PROPOSAL

Construct a two-story addition to a ca. 1951 house.

STANDARDS FOR REVIEW

STAFF RECOMMENDATION

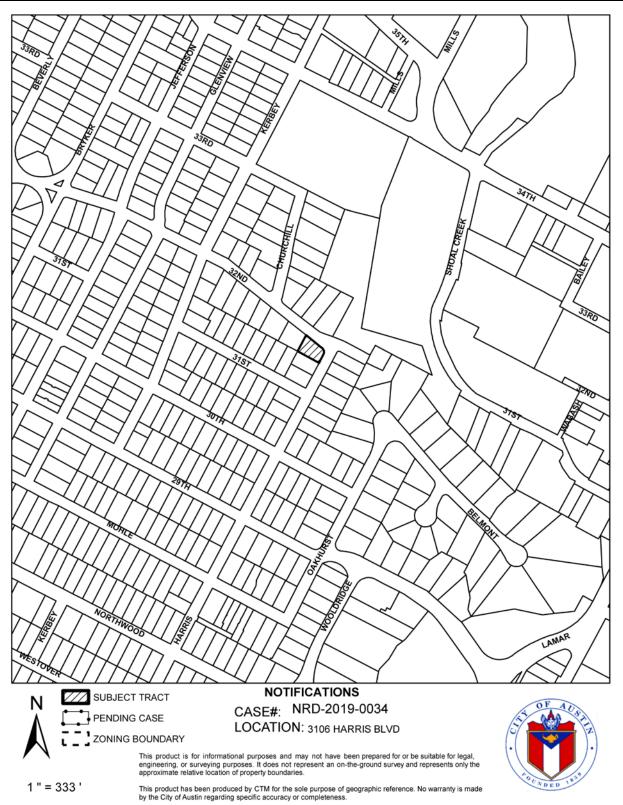
The proposed work is differentiated from the old via the modern fenestration patterns and two-story form. The proposed second floor is flush with the primary façade and is not compatible with the one-story scale and massing of the historic structure.

Postpone the public hearing to June 24, 2019 to encourage the property owner to consider design alternatives that would maintain the property's contributing status; If the Commission elects to make a decision at this meeting, staff recommends commenting on and releasing the plans upon completion of a City of Austin Documentation Package.
